Product Change Notice (PCN)

PCN Number: PCN-0450007R-01

Product(s) Affected:
SJ-43504-SMT-TR

1. Minor Housing Differences

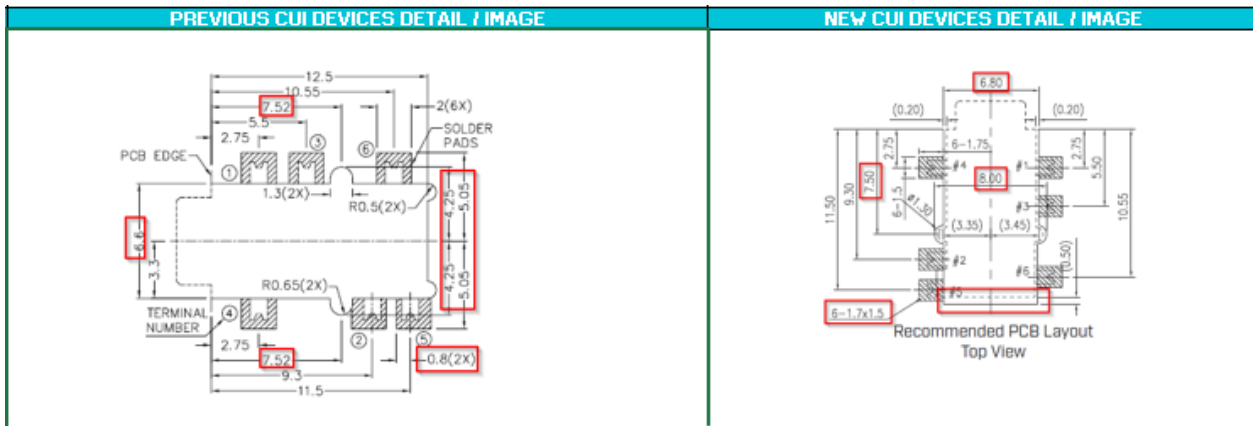
2. Minor PCB Differences
